SERVICE BULLETIN SB-00027

Subject: Changes to RV-14A Nose Gear Attach Opening/Washer

Affected Models: RV-14A
Affects the nose gear on all RV-14A Finish Kits delivered prior to November 4, 2020

FIGURE 1: SEVERED FUEL PUMP INLET FITTING DUE TO NOSE GEAR COLLAPSE DURING EMERGENCY LANDING

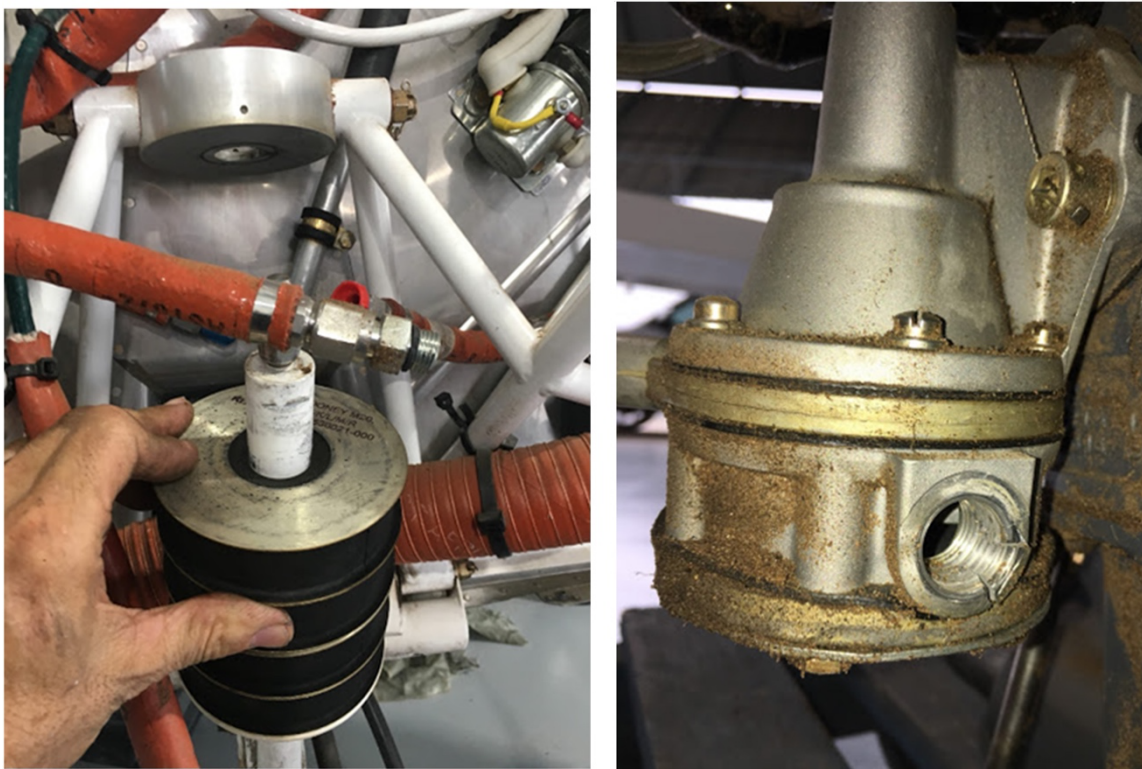
Data from the field suggests that, during a nose gear collapse, the upper end of the U-01416 Nose Gear Link Assembly can strike the fuel pump inlet fitting that is directly ahead of it, severing the fitting from the fuel pump along with the attached VA-139 hose. Refer to Figure 1.

Tests at Van's Aircraft have verified that after enlarging the opening on the U-01406 Nose Gear Leg where the U-01416 Nose Gear Link Assembly is attached, the possibility of this scenario is eliminated. This is the case because after the modification, the upper end of the of the U-01416 Nose Gear Link Assembly will pass beneath the fuel line when the nose gear is deflected aft.

FIGURE 2: EXCERPT FROM RV-14 KIT ASSEMBLY INSTRUCTIONS PAGE 40A-06

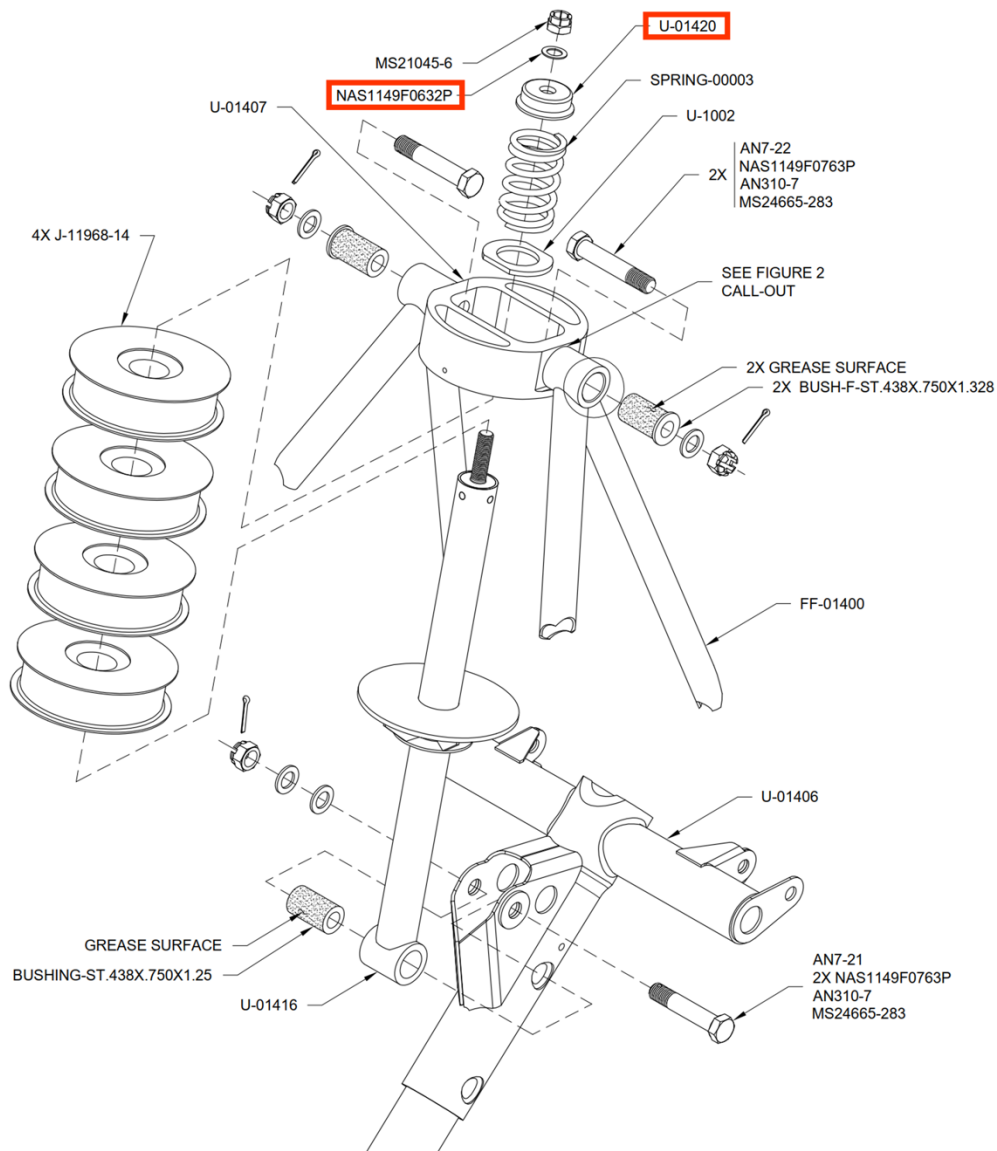
Step 2: Either replace the NAS1149F0632P washer with the larger WASHER-00023, or replace the U-01420 Link Assembly Cap with the newer U-01420-1.

Fully torque the MS21045-6 nut, per Kit Assembly Instructions page 40A-06.

FIGURE 3: ENLARGING THE OPENING ON U-01406.

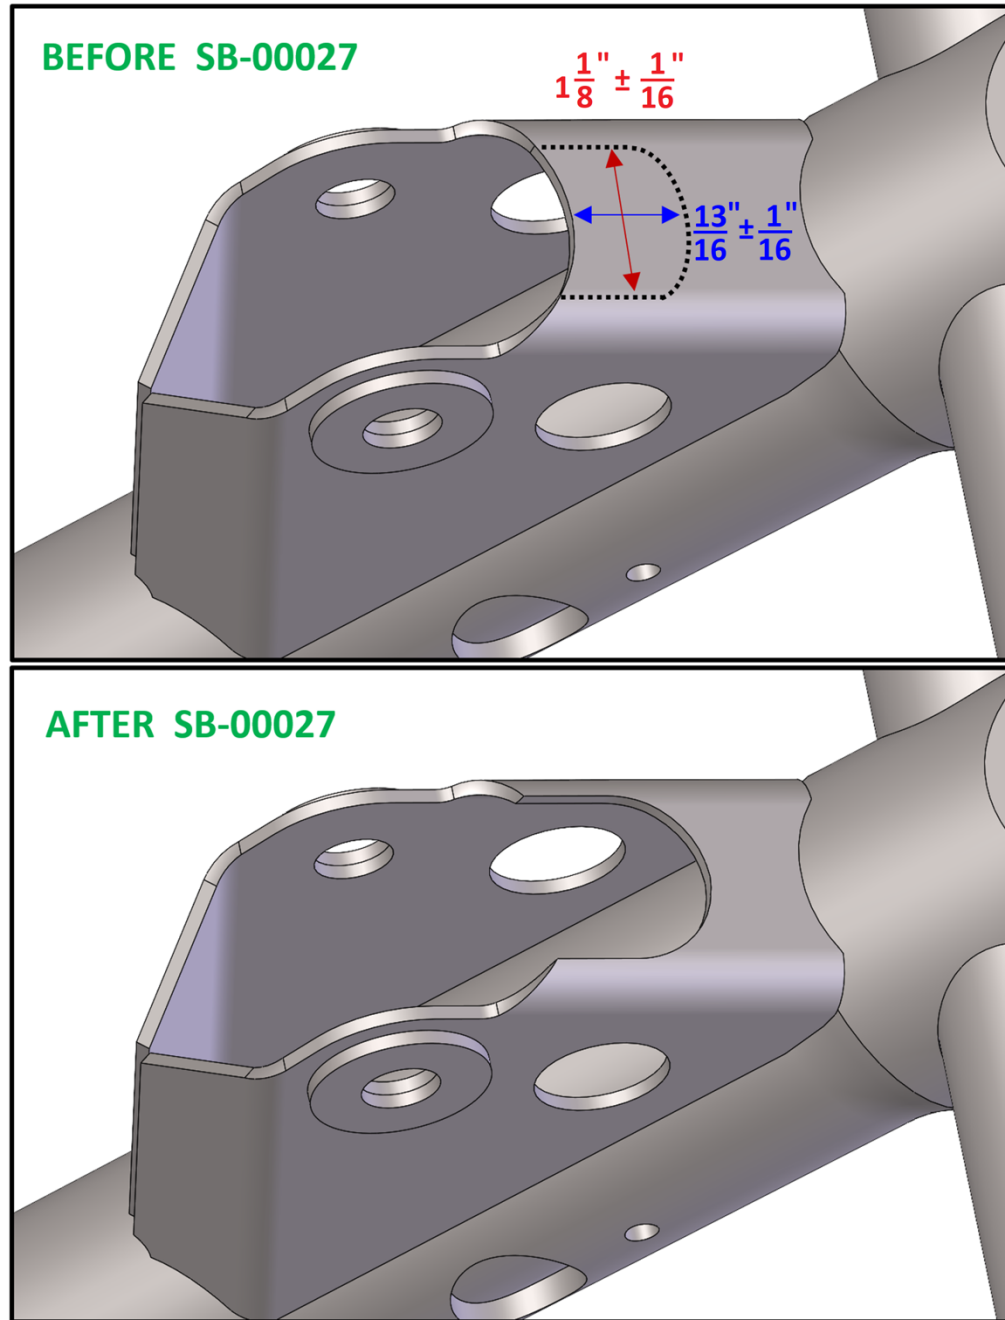
Date Released: April 2, 2021 (Rev 1 - Updated Figure 3, notch width matches new factory part dimension – see notes)
November 5, 2020 (Initial Release)

Step 5: Cut and/or grind material from the aft end of the opening on the Nose Gear Leg where the Nose Gear Link is attached. Sand the surface of the cut until it is smooth. Refer to Figure 3.

Step 6: Apply a coat of paint onto the exposed steel along the new edge of the opening, for corrosion prevention. Van's recommended paints for powder-coated parts can be found in our web-based FAQ, at:
